Reviewer Responses to HESS comments re:

Leveraging a time-series event separation method to untangle time-varying hydrologic controls influence on wildfire disturbance on streamflow

Figure 6: Undisturbed rainfall-runoff event KDE distributions for hydrologic conditions for natural log transformed WYT, season, and antecedent precipitation in (a) Arroyo Seco and (b) Clear Creek for four selected runoff metrics: volume, peak, duration, and response time.

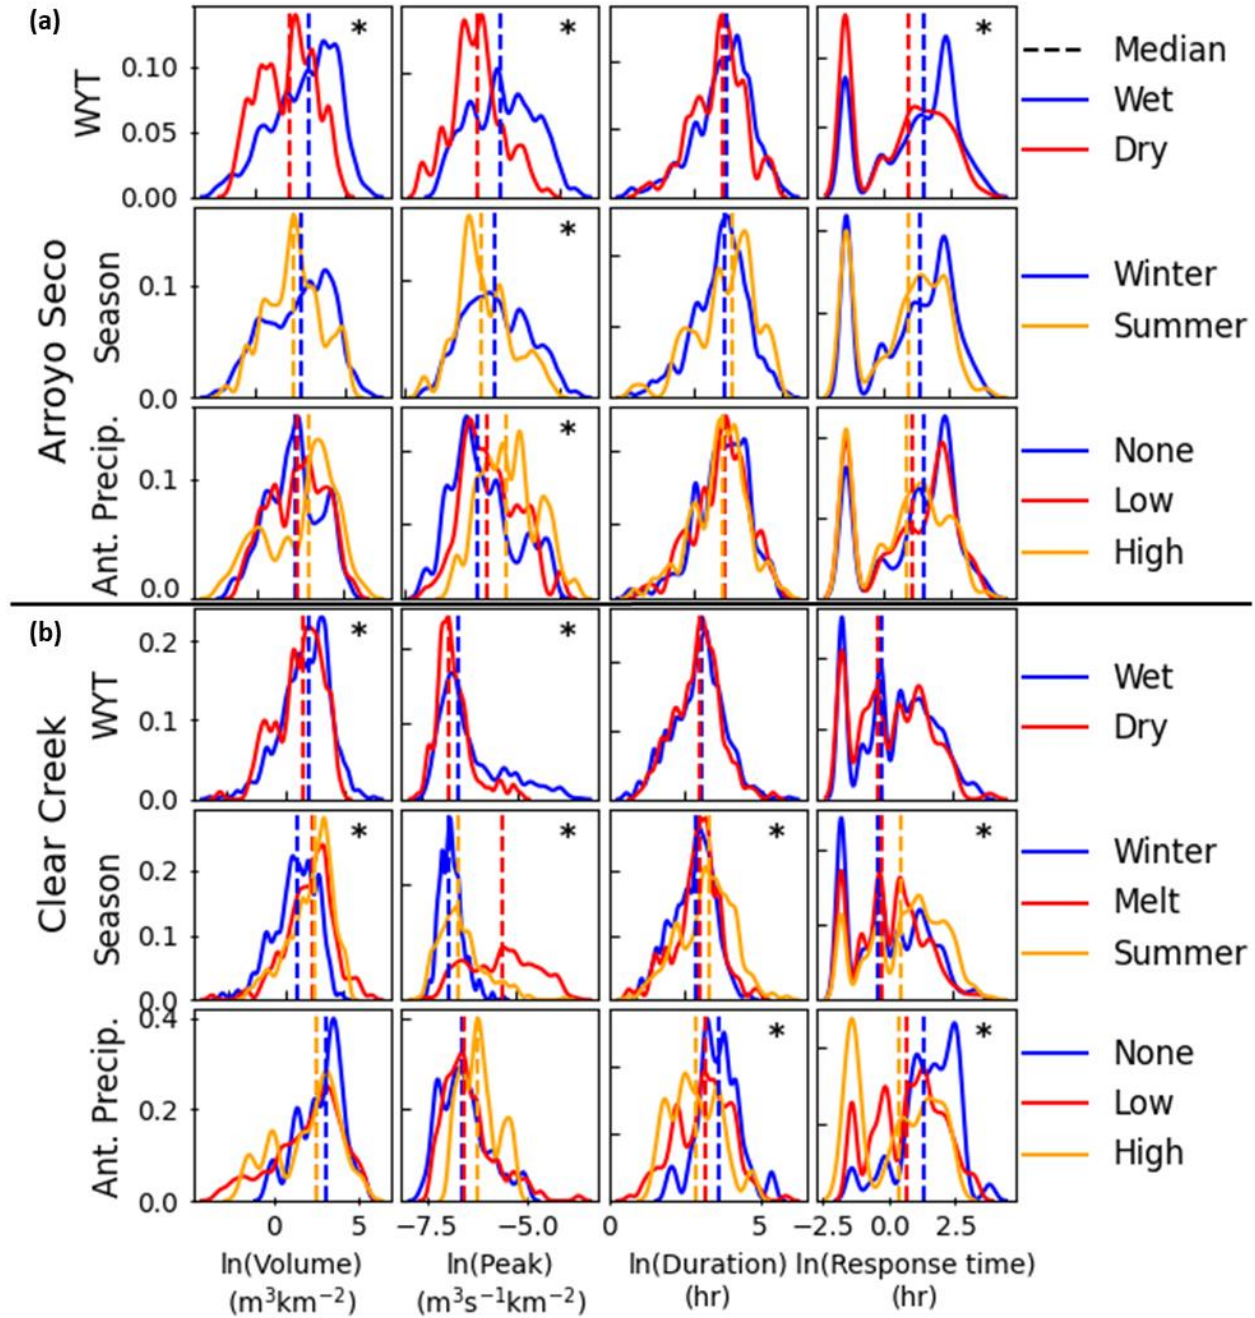
6. Figure 6: Can you explain what negative values on the x-axis for volume, peak flow and response time mean?

Plotted values are representative of the natural log (\ln) of the volume, peak, duration, and response time metrics. As such, values can be negative if less than 1. We have updated the figure so that this is noted appropriately in the x-axis labels. We have clarified this is the natural log transform in the Fig. 6 caption.
